NUMBER
PTR13058

**SOLICITATION NUMBER:** PTR13058  
**Addendum Number:** 4

**TECHNICAL QUESTIONS/ APPROVED EQUALS ON PTR13058**

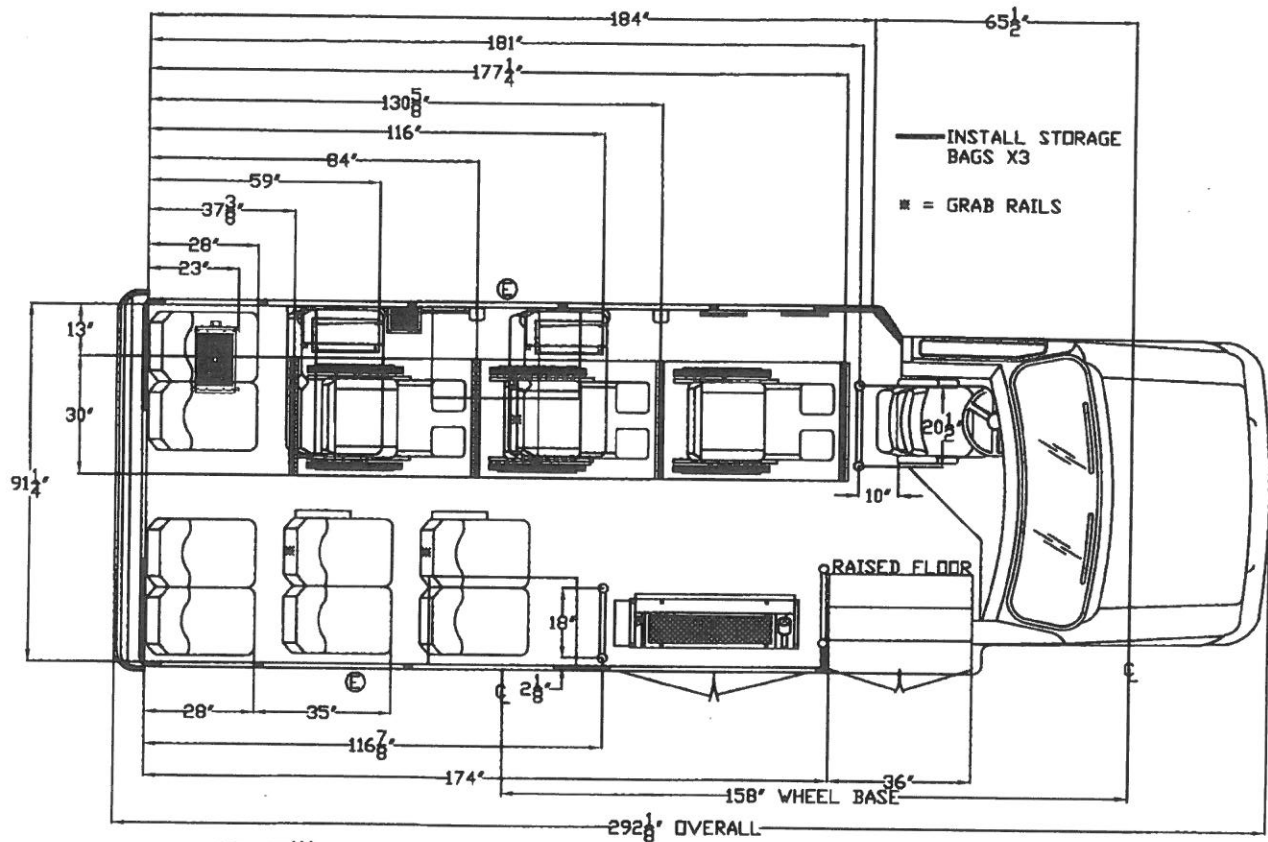
On page seven of the approved equals; 4.5.1 it is stated that Class E should be 4 ambulatory + 3 tie down positions (Floor Plan 2) would be preferred. Floor plan 2 has 8 ambulatory passengers. Can you clarify?

**WVDPT prefers 8 ambulatory passenger seats and 3 tie down positions, with four additional foldaway seats in the tie down area, as is shown in floorplan two (attached).**
